Service Bulletin

Subject: Diagnostic Tip - Rear Toe Adjust Link Dampener Service Guidelines

Models: 2010 - 2014 Buick Lacrosse (built prior to 02/19/14)
equipped with 4 Link Rear Suspension (RPO GNC)

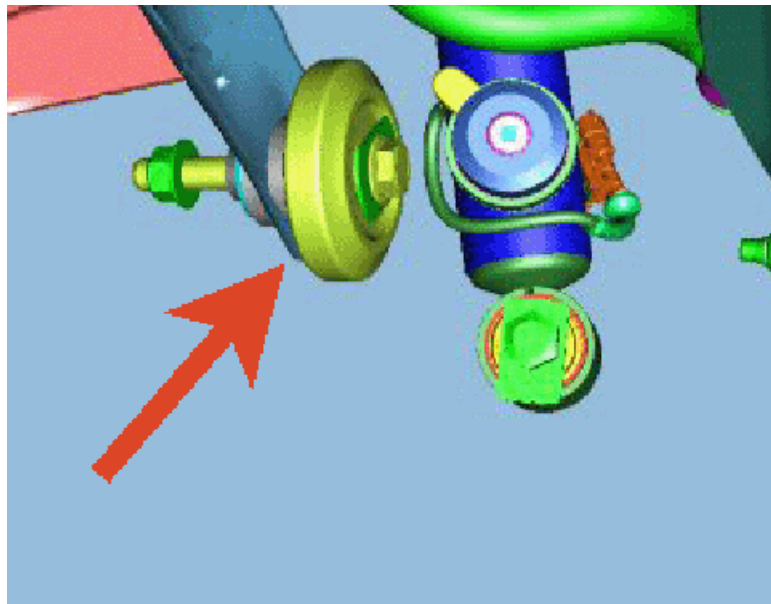
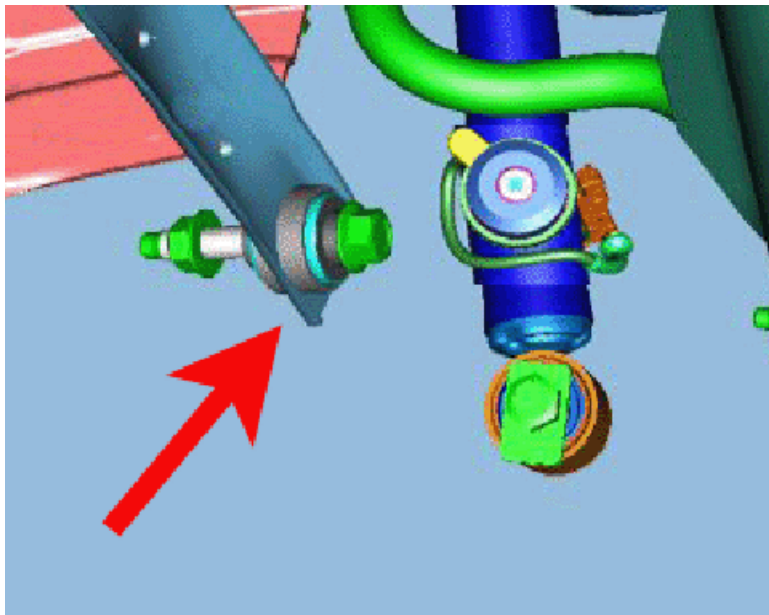
Vehicles listed in the Models section above were built with a dampener on the rear toe adjust link - as reflected in the first image below.

Engineering has determined that this dampener does not make a noticeable impact on noise, vibration, or harshness. Therefore, it has been eliminated from production in February 2014.

The two photos below show the link with and without the yellow dampener. The second image below shows the shorter bolt without the dampener and washer.

If making a repair on a vehicle in which this dampener has been damaged or needs to be replaced, you may remove the dampener and washer and replace with a shorter bolt (GM P/N 11561300). The nut remains the same. Discard the factory-installed dampener and washer.

Note: It is also acceptable to have a dampener on one side only if the other side was unaffected during a particular repair.
